Response to various bushfire issues raised by RFS  
Narrabri Gas Project

**Santos Limited**

| <b>Project Name</b>    | Santos NGP Management Plans                               |

**Figure 1: Diagrammatic view of the dimensions of the well pads**

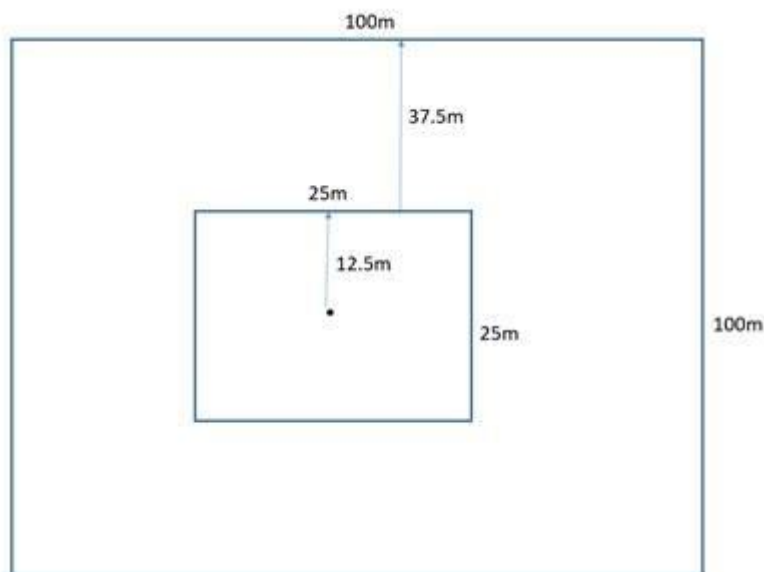
**3. Response to RFS issues dated 23.5.18****3.1 APZ and exclusion of flame contact for surface infrastructure**

Of the remaining surface infrastructure (primarily the well heads) the highest predicted Radiant Heat Flux (RHF) and Flame Length was determined using the highest locality-wide inputs for effective slope, predominant vegetation, Generalised Extreme Value<sub>50</sub> for weather and then assessing this against the smallest permissible APZ for the infrastructure (see **Figure 1**).

This process results in the worst-case bushfire risk and analysis of this (see **Table 1**) and it shows well head infrastructure (apart from roads and fences) are located where the RHF is below 14kW/m<sup>2</sup> and there is no Flame Contact from unmanaged vegetation.
